### ADDENDUM 3

**BID TITLE: File No. 39-25 Taxi V Extension Construction**

BID FOR Taxiway V (Victor) Extension

**TYPICAL SECTIONS**

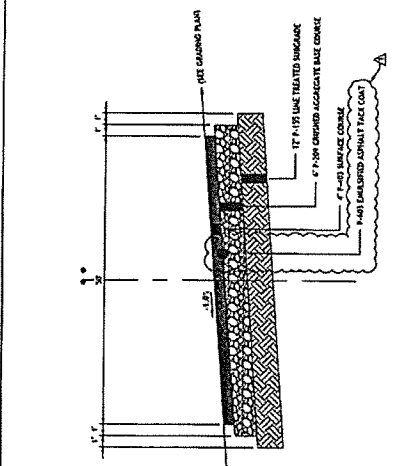
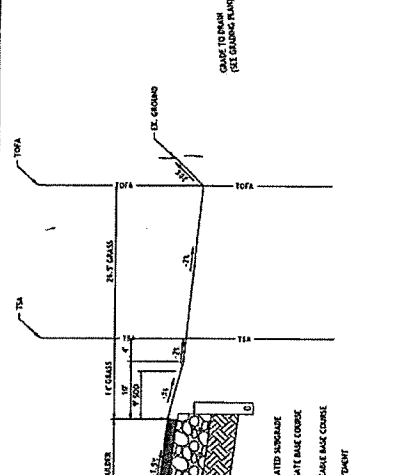
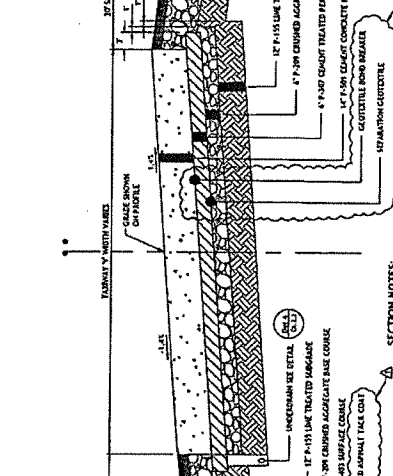
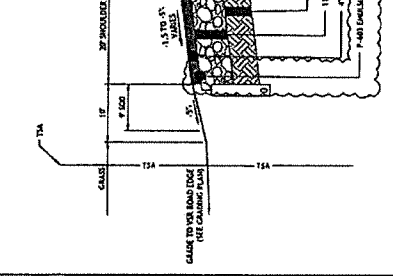
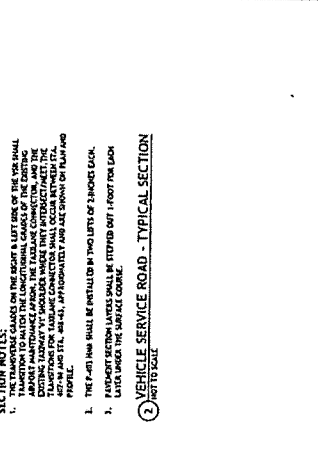
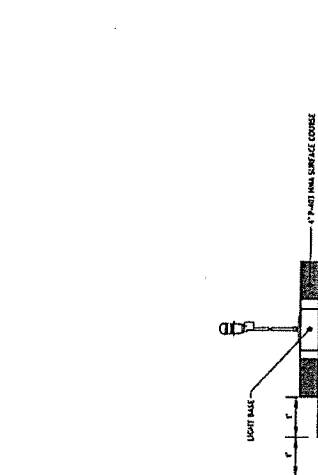
9.	<b>Question</b>	P-307 Cement Treated Permeable Base under the Materials section calls for a Bond Breaker Fabric (307-2.7) and a Separation Geotextile (307-2.8). Under basis of payment (307-7.1) it states the placement of overlaying bond breaker is included in the Cement Treated Permeable Base. There is no mention of the Separation Geotextile to be included in the cost. Please advise if a Separation Geotextile is to be included in the unit price for the P-307 Cement Treated Permeable Base. If not, will a separate bid item be added? Please also update the Pavement Typical Sections depicting the Bond Breaker Fabric and Separation Geotextile for clarity.
	<b>Answer</b>	<b>The standard form of the FAA specification is used. The intent is that all geotextile for Bond Breaker above the P-307 layer and the separation geotextile beneath the P-307 layer shall be included in the square yard measurement and payment for P-307 Cement Treated Permeable Base. See revised detail in file titled "Typical Sections" included with Addendum 3.</b>
